NORTHERN BEACHES LOCAL PLANNING PANEL

WEDNESDAY 5 APRIL 2023

ITEM 4.1	DA2022/1650 - 8 BAROONA ROAD, CHURCH POINT - ALTERATIONS AND ADDITIONS TO A DWELLING HOUSE INCLUDING A SWIMMING POOL.
AUTHORISING MANAGER	Adam Richardson
TRIM FILE REF	2023/181592
ATTACHMENTS	1 ↓ Assessment Report 2 ↓ Site Plan & Elevations

DEVELOPMENT APPLICATION ASSESSMENT REPORT

Figure 6. June 21 9am Shadow Diagram (orange highlighting new shadows).

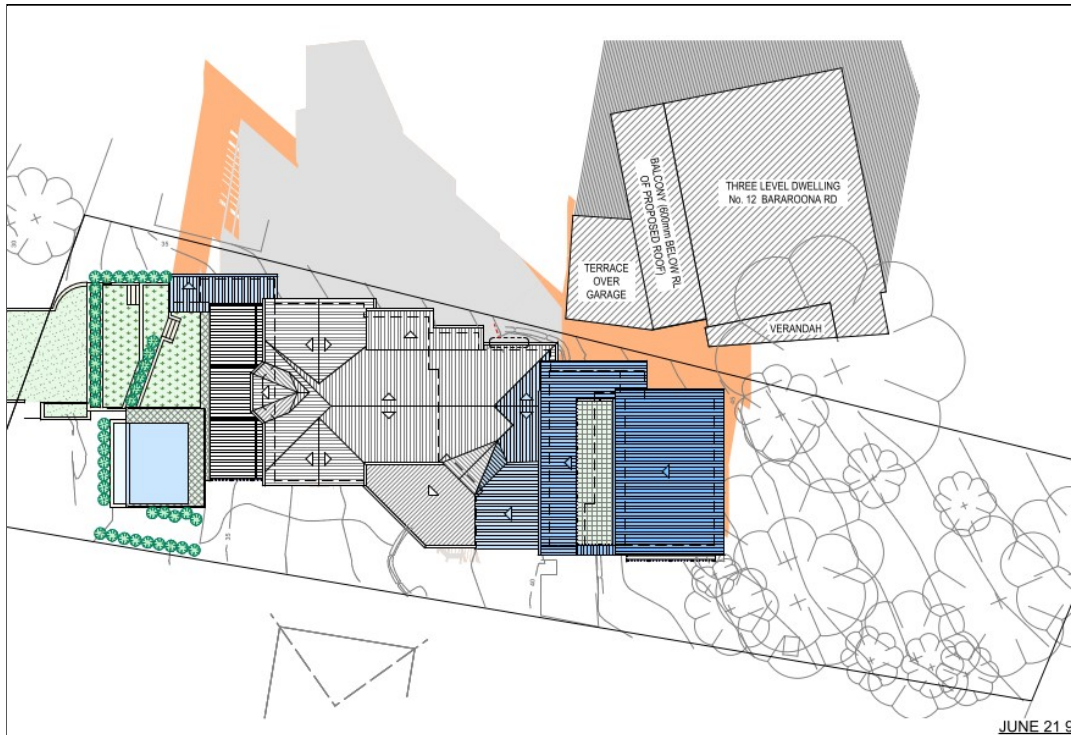
The proposed development will result in overshadowing to the private open space of No.10 Baroona Road as detailed on the 9am Shadow Diagram (see Figure 6) and 12pm Shadow Diagram (See Figure 7) on 21 June. The proposal will unreasonable result in the reduction of solar access, and it is considered that the proposal presents a reduction in solar access that is less than the minimum of 3 hours of sunlight between 9am and 3pm on June 21st. The proposal will continue to maintain a minimum of 3 hours of sunlight between 9am and 3pm on June 21st to the windows of the principal living area of N0.10 Baroona Avenue.

The proposed development **does not satisfy** this outcome.

Figure 8. South East Elevation of No.8 Baroona Road

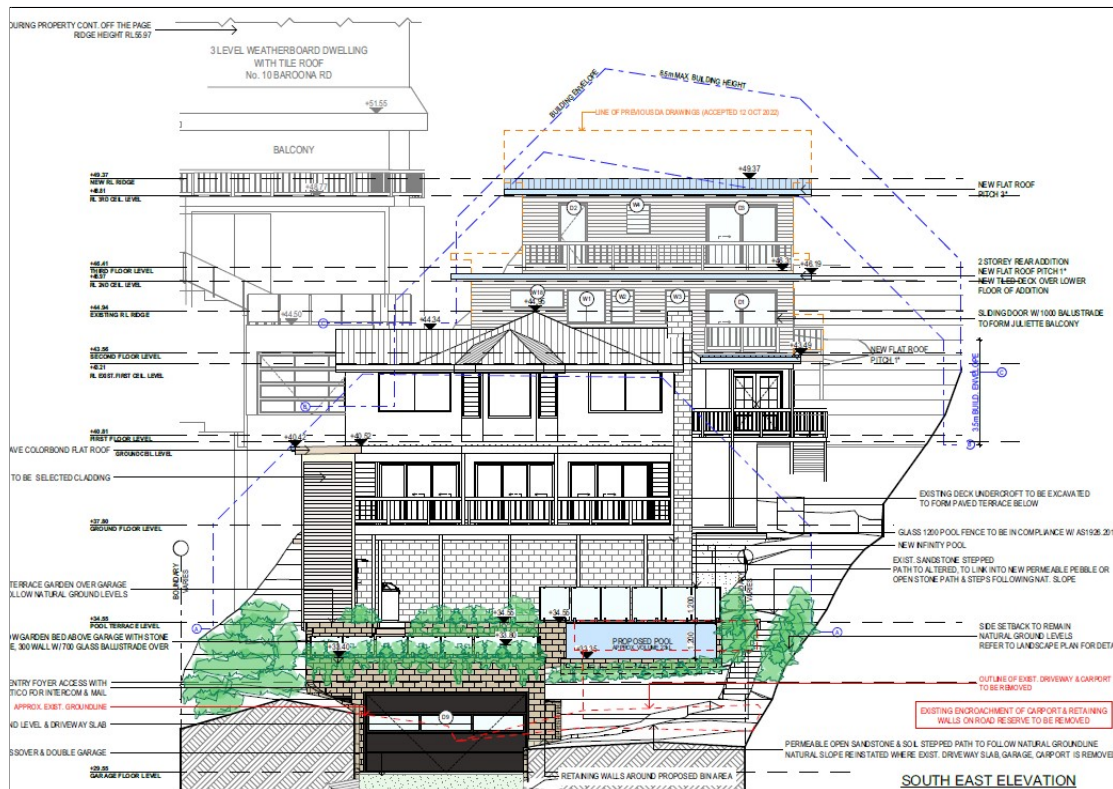
The proposed development as viewed from a public place is detailed on the South East Elevation (see **Figure 8**).

The application is considered to be inconsistent with the following requirements as detailed under Clause D4.1 Character as viewed from a public place of Pittwater 21 Development Control Plan:

Figure 9. Existing Landscaped Area Plan

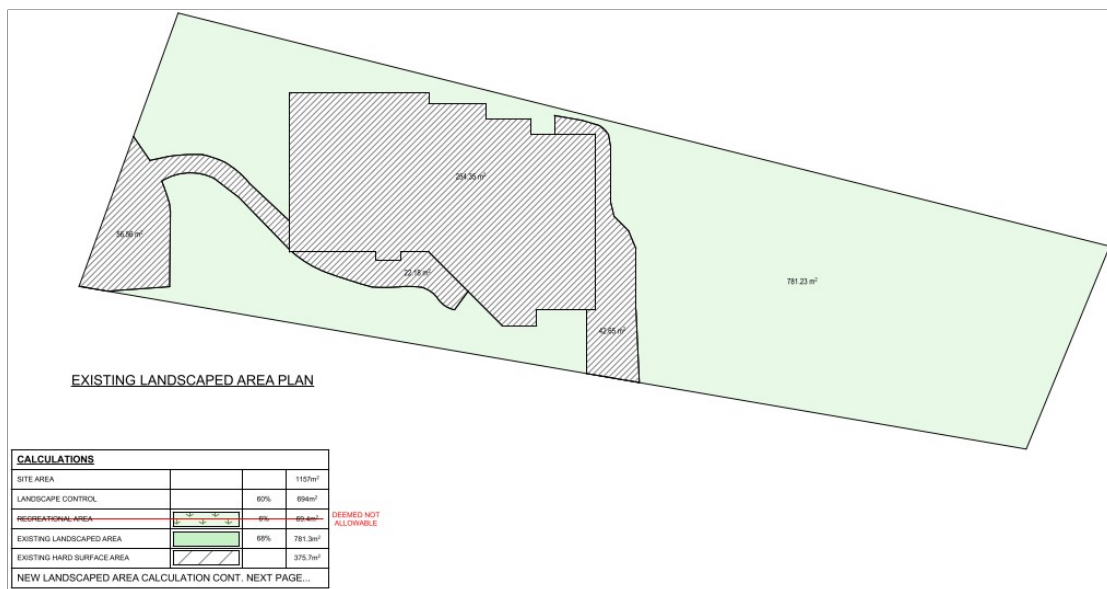
The existing landscaped area on site is compliant at a total of 67.52% (781.23m²) as detailed in Figure 9. The existing site presents a compliant Landscaped Area, and as such the proposed development presents an unacceptable reduction in landscaped area that is representative of an over-development to the site.

Figure 1 - East Elevation showing envelope encroachment in red

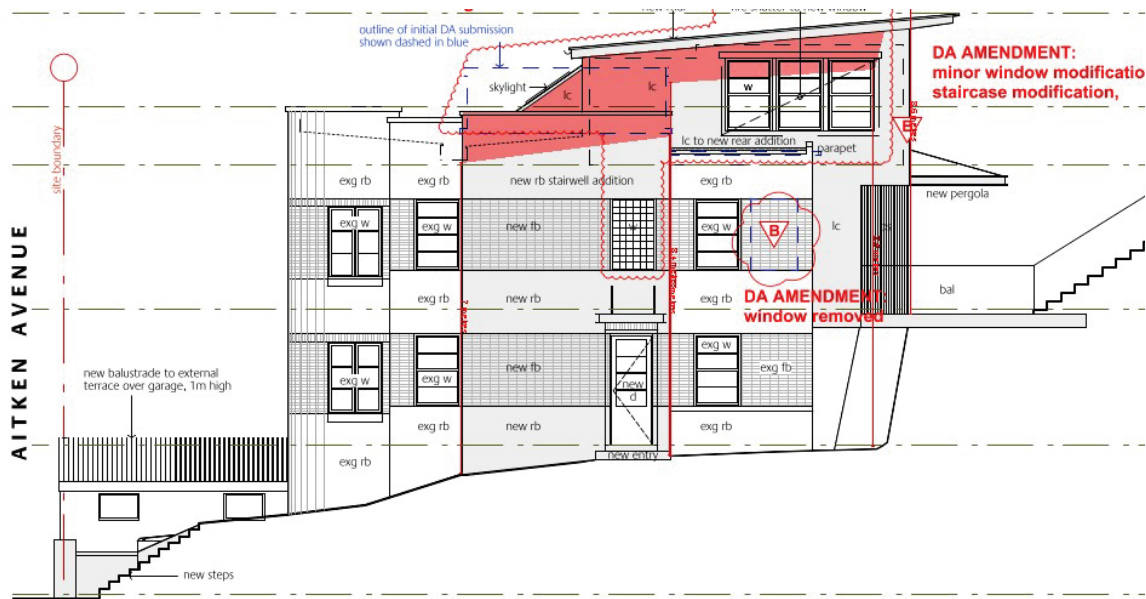
The site is subject to a building envelope determined by projecting planes at 45 degrees from a height of 5 metres above ground level at the side boundaries. The proposal encroaches both the eastern and western side boundary envelope. Following a request for additional information, amended plans were received which increased the side setbacks of the proposed second floor by 0.5 metres to each side. This resulted in a reduction in both side boundary envelope breaches.

Figure 2 - West elevation showing envelope encroachment in red

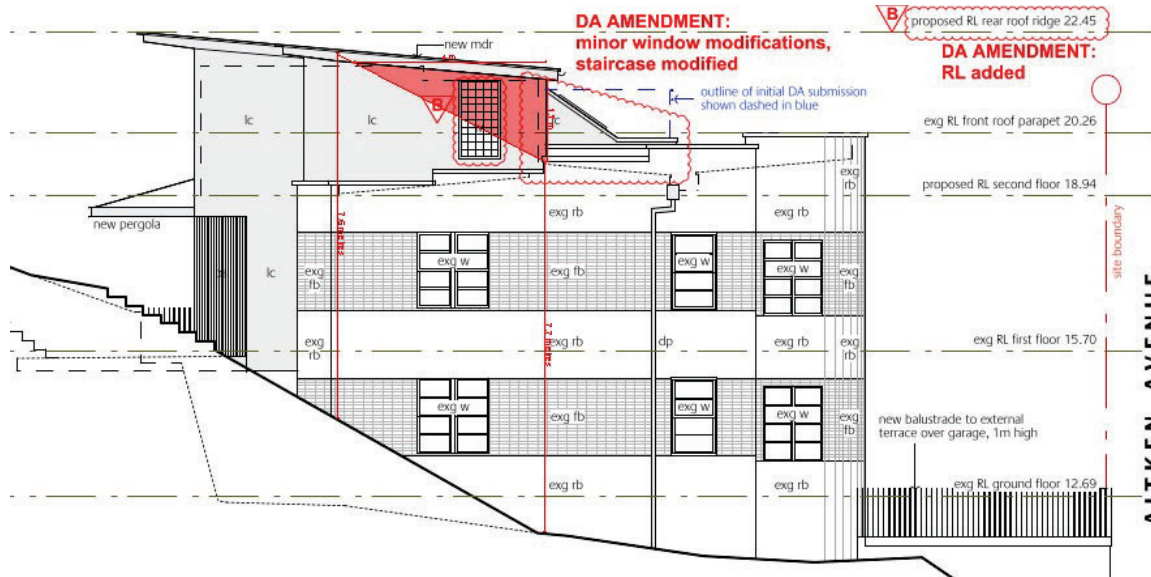
The bulk and appearance of the resultant built form is consistent with that of the surrounding development and is considered acceptable notwithstanding the non-compliance with the envelope control. An assessment against the objectives of the side boundary envelope is provided below.

Figure 3 - Extent of Height Breach

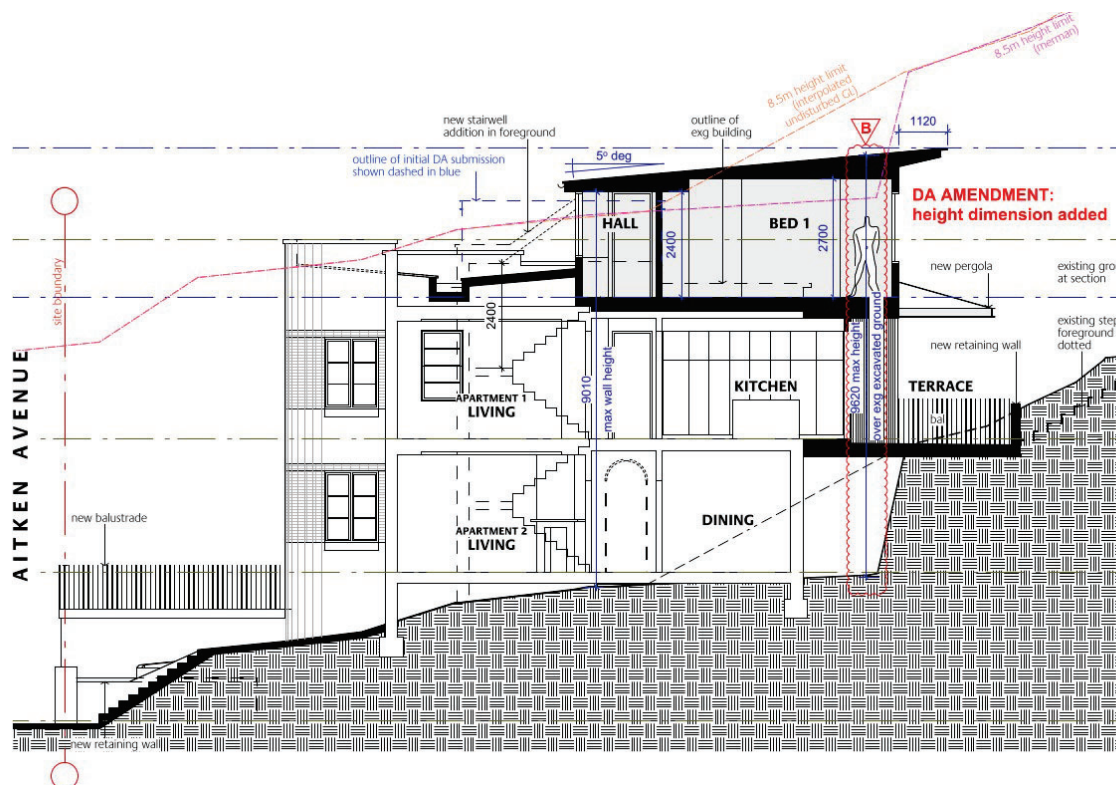
Development standard:	Height of buildings
Requirement:	8.5m
Proposed:	9.62m
Percentage variation to requirement:	13.18%

Figure 6 - Perspective images showing the existing and proposed development as viewed from the balcony of 10/132 Queenscliff Road (Provided by the applicant)

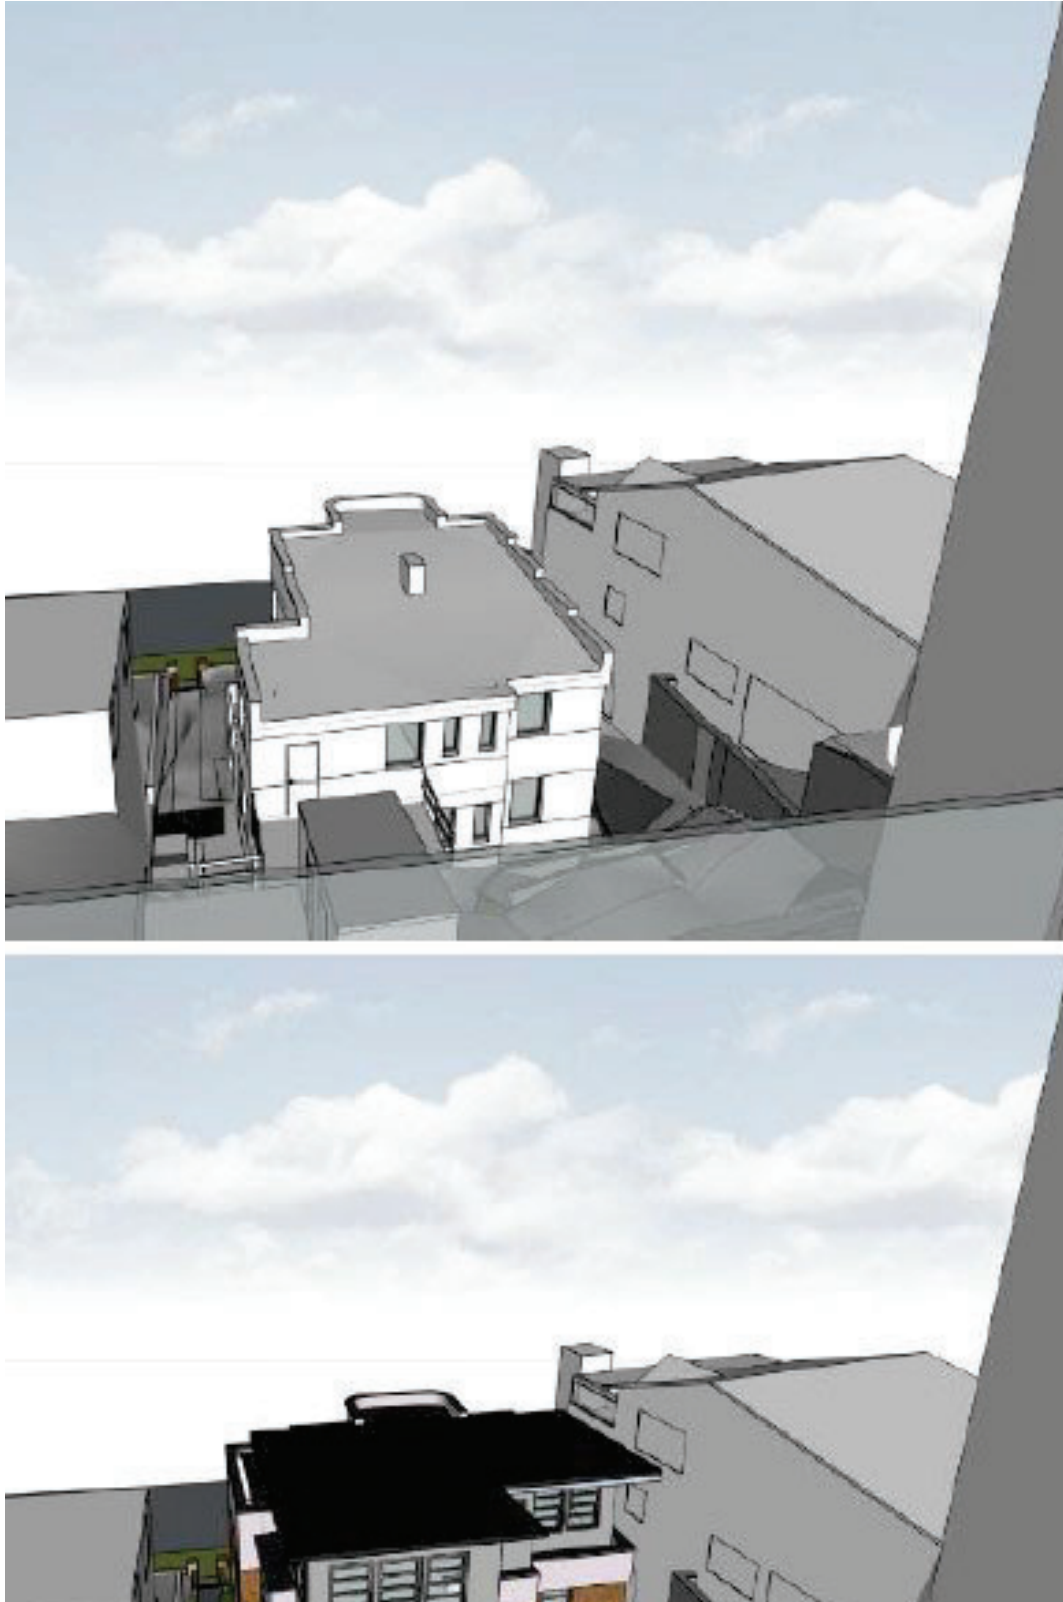
The proposal retains the district views over Queenscliff as well as the water views of Manly Lagoon. A small portion of the water views of the Lagoon obtained from the bedroom will be impacted by the proposal. It is noted that this view is currently obscured by an existing Palm Tree whereby the impact of the proposal will be minor. The new roof to the second floor does not extend further south and sits behind the existing parapet at the front of the site. The slope of the roof down towards the southern street frontage also reduces the overall height and view impacts of the second floor addition. This ensures that the extent of the existing view of the lagoon is retained along with the land water interface as seen in Figure 6 below provided by the applicant. The proposal will impact the views of the grass and carpark area of Aitken reserve obtained from the balcony. The water views of the Lagoon and the district views will be retained and the view loss is considered negligible.

Figure 1 – Plan extract showing the extent of building height breach along the southern edge of the proposed upper-level additions with the extent of breach consistent with the existing upper-level parapet breach associated with the 2 storey street facing building element

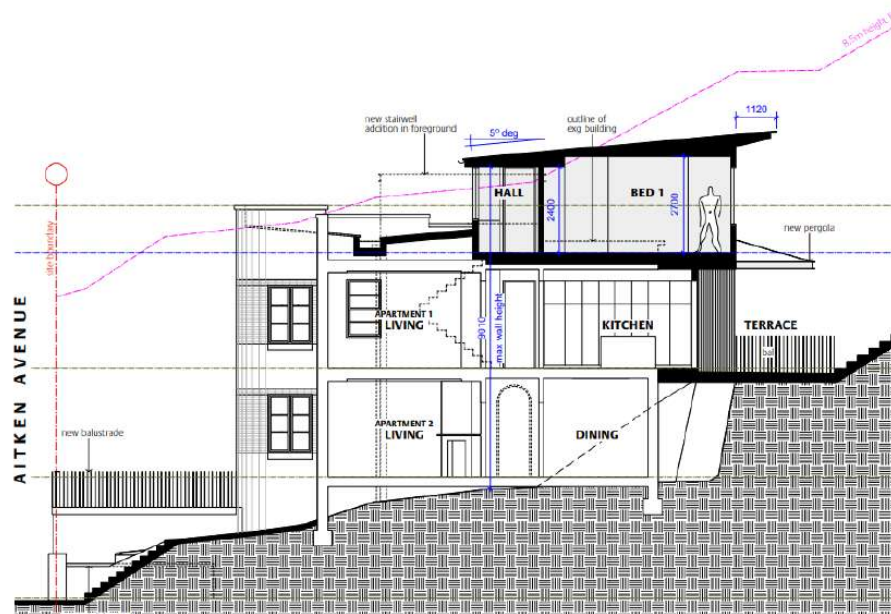
It has been determined that the southern edge of the upper-level additions breach the 8.5 metre building height standard by 950mm of 11.1% with the extent of breach consistent with the existing upper-level parapet breach associated with the 2 storey street facing building element as depicted in Figure 1 below.

Figure 1 - Extent of non-compliance with 8.5m height standard

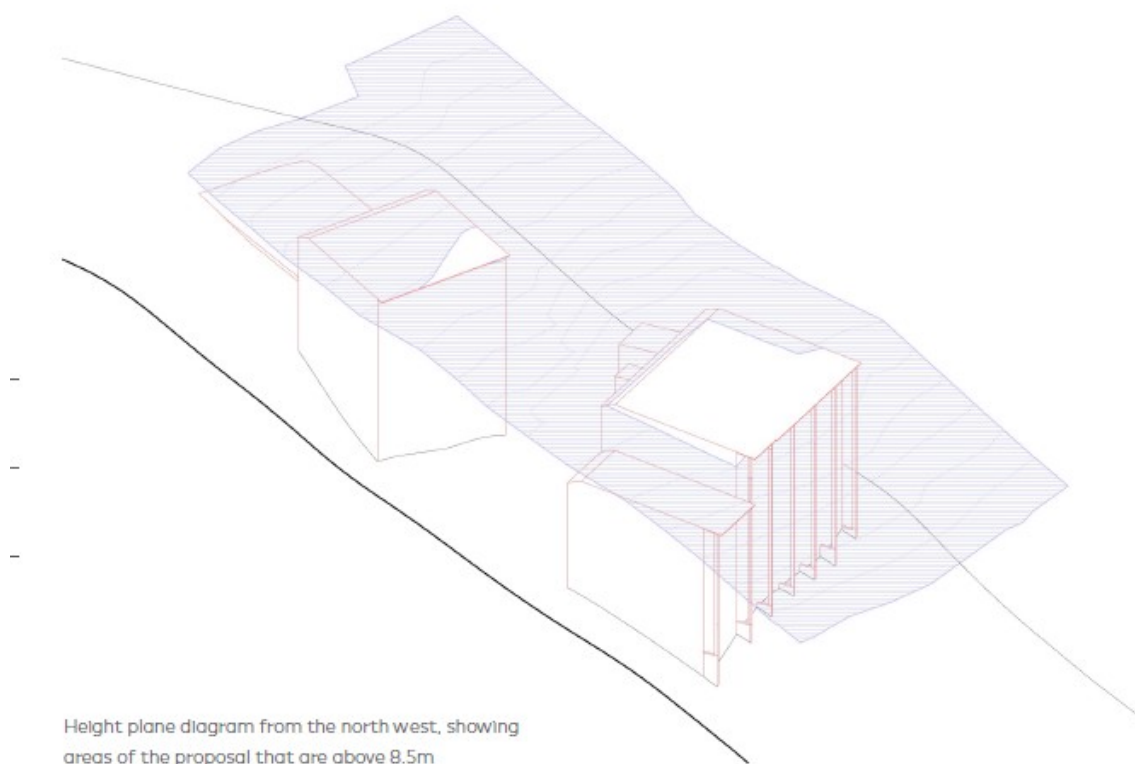
Development Standard	Height of Buildings
Requirement	8.5m
Proposed	Dwelling - 9.5m (max) Garage - 9.0m (max)
Percentage variation to requirement	Dwelling - 11.7% Garage - 5.8%

Figure 2 - Eastern (street) elevation of the garage level

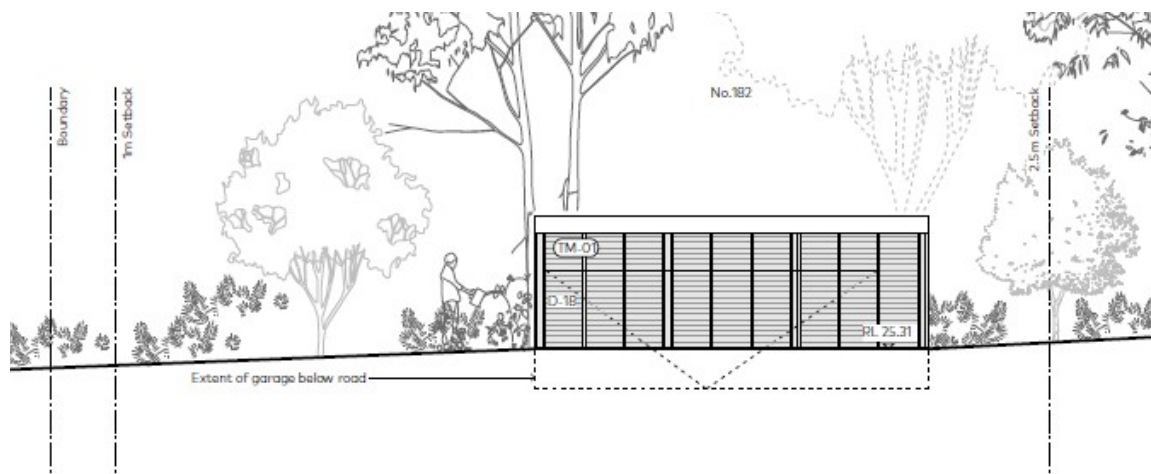
The proposed dwelling has a varied setback from 5.8m to 14.2m and the garage/workshop/storage structure has a nil to 0.5m setback, both of which do not comply with the 10m front setback control.

Figure 3: Extent of non-compliance with the side building envelope at southern elevation (shown in green cross-hatch)

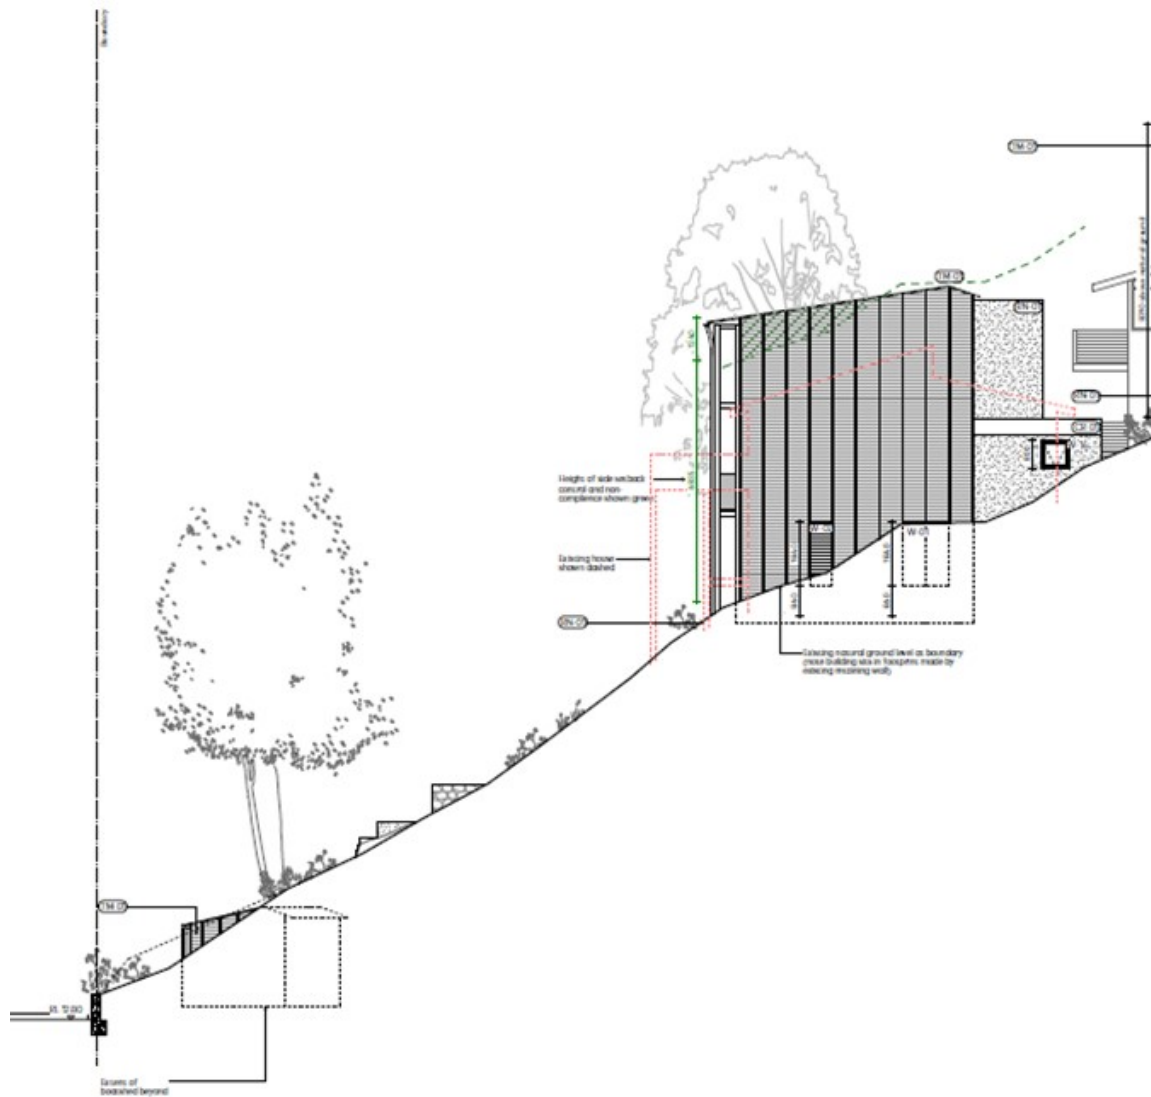
As the slope of the building envelope for the dwelling and garage both exceed 30%, the following merit assessment was undertaken.
